#### CITY OF TONTITOWN PLANNING OFFICE

Meeting: **November 1, 2021**Project: **Mathias Warehouses**Planner: Nathan Crouch

#### PRELIMINARY LARGE-SCALE DEVELOPMENT PLAN APPROVAL REQUEST

### Mathias Warehouses Preliminary Large Scale Development Waiver and Variance Requests

This document, and the ideas and designs incorporated property of Crafton, Tull & Associates, Inc., and is not to be used, in whole or in part, for any other project, without the

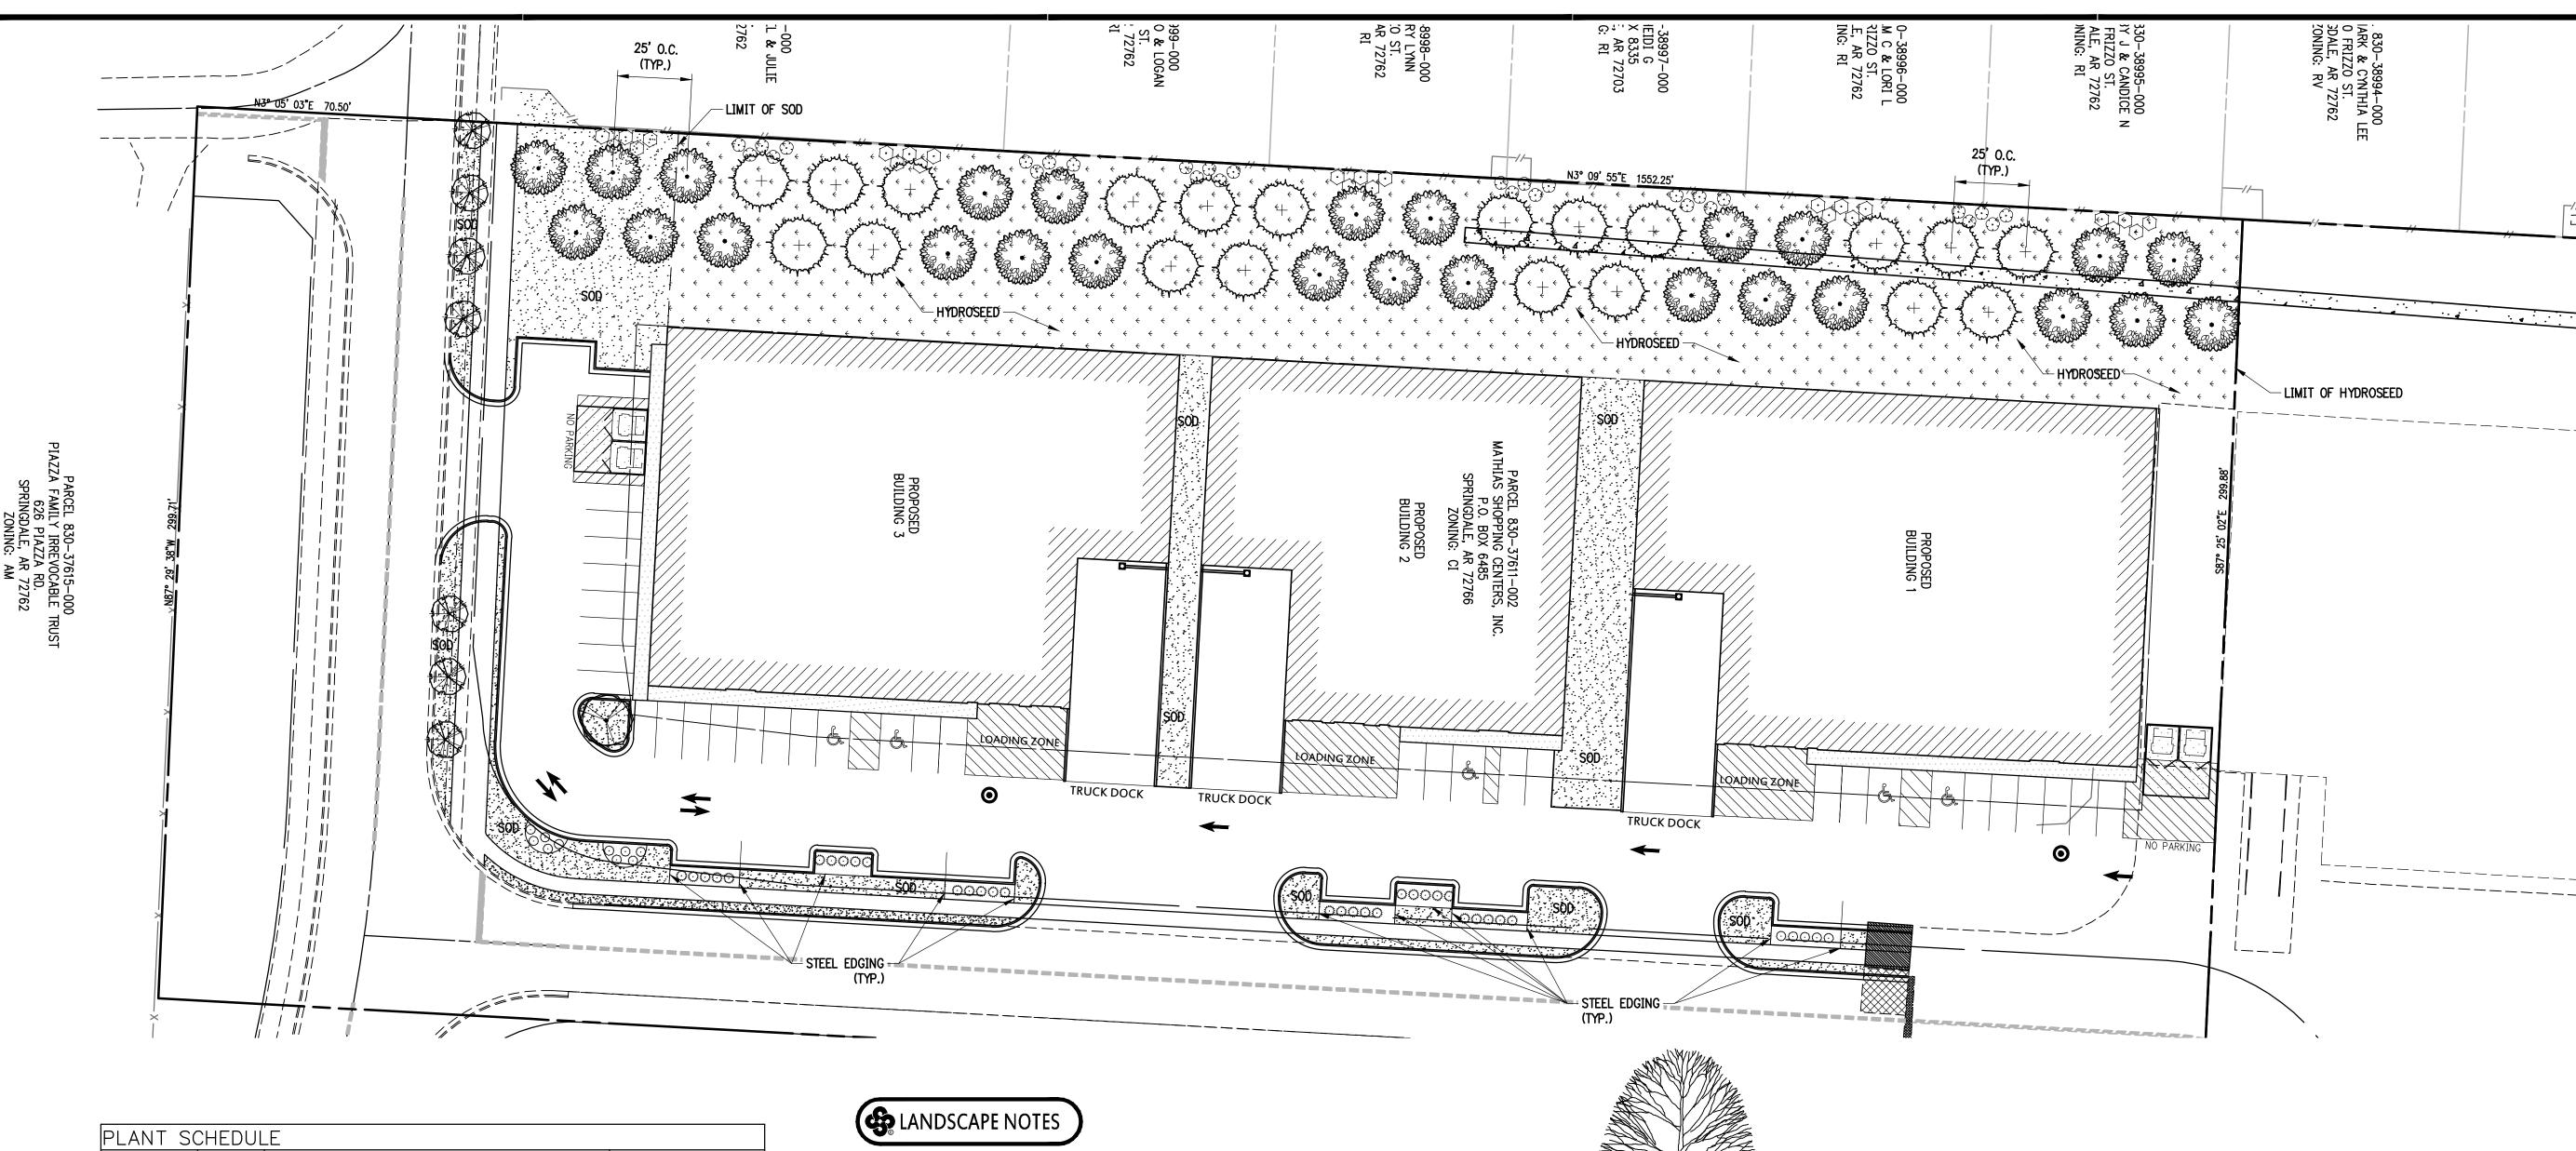
- 7. Provide a drainage easement to the detention pond since a portion of the proposed detention is located on an adjacent parcel.
- 8. Show irrigation method to the proposed landscaping and the landscaped plan must be signed by a landscape professional.
